Dominion Terminal Associates LLP

August 17, 2021

Attention: Mr. Steven J. E. Long
Re: June 17, 2021, Inspection on VPDES Permit #VA0057576

The above pictures reference (Swales needing cleaning), your pictures #2, 3 & 4 correspond with our pictures showing the issues remediated.

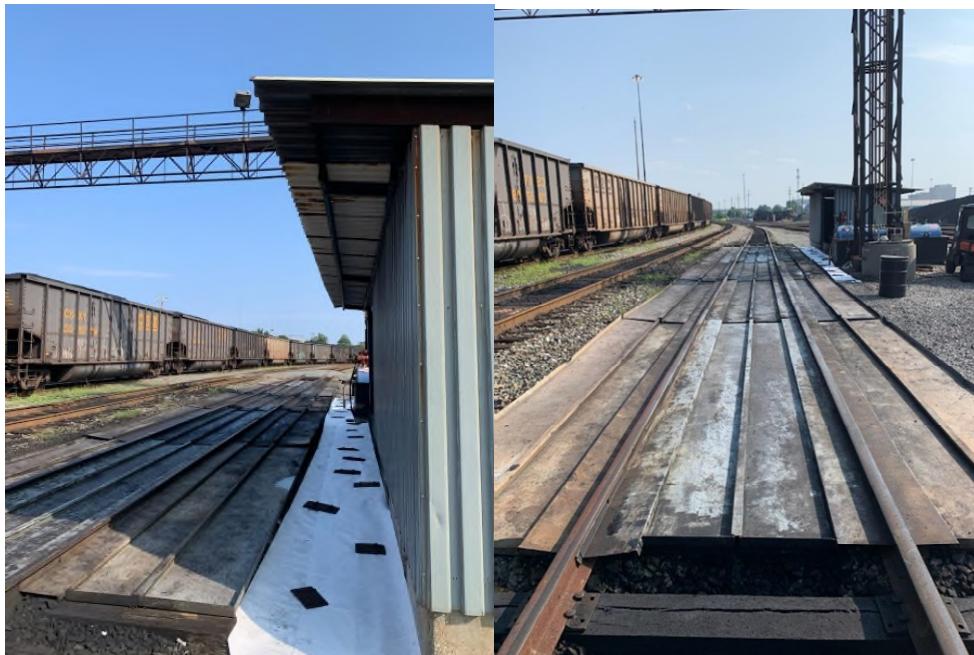
- The survey started at the south side of the facility from the administrative building to the surge silos, to Ponds 1-3, the south maintenance building and then ended at the north maintenance building. The entire site was not observed with the interior area of coal pile and stacker/reclaimers only viewed from a distance. Travel from the south was along the maintenance road that parallel the drainage ditch on the east site. Several areas were observed with coal fines on the roadway and in the various conveyances to the pond that will need routine cleanup. Cleaning was observed in one area and likely continues as needed at the other areas. The north maintenance area was improved from previous visits though housekeeping can still be implemented for the swales filled with solids

and oil spills and stains observed. See photos 2-4, 14, 17-20 for some examples of areas needing cleanup.

- We cleaned out the coal fines in the swales. (see attached pictures)
- The oil spills were remediated. (see attached pictures)
- The north maintenance area did have spills that should be cleaned up. A railway spill pad had some spillage on the pad that could be cleaned up and prevented from reaching the oil water separator associated with the pad. Cleaning eliminates the entrainment of the oil in the stormwater and will extend the time for cleanout of the separator. See photos 14-16.

The above pictures reference (Locomotive Service Track), your pictures #19 & #20 correspond with our pictures showing the issue remediated.

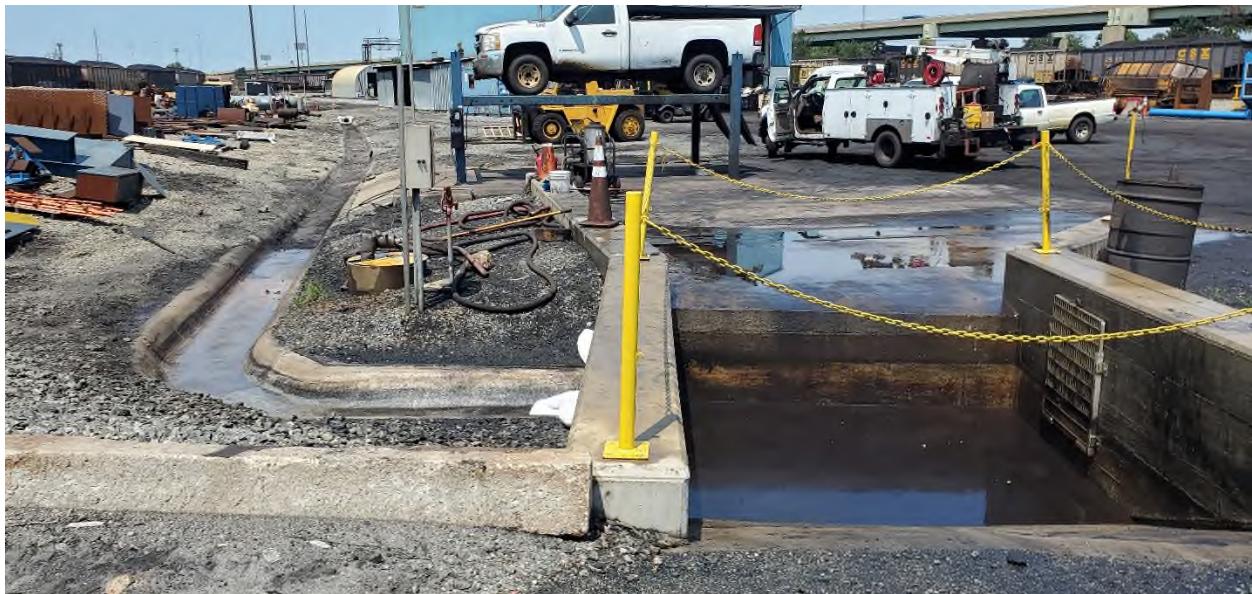
- We cleaned the spill pan and surrounding area. (see attached pictures)
- Spillage was also observed near a locomotive near the maintenance building with free product on a spill pad. The liquid can be removed eliminating the exposure and will prevent runoff to the gravel in the areas. See photos 19 and 20.

- The Service Track oil spill was remediated. (see attached pictures)
- Multiple conveyances and buildings were observed at the facility that are not shown on the site map. See photos 1-5, 9, 1117-19, 22 and 23. All conveyances and structures are to be shown on the site map. See below for map requirements and citations.
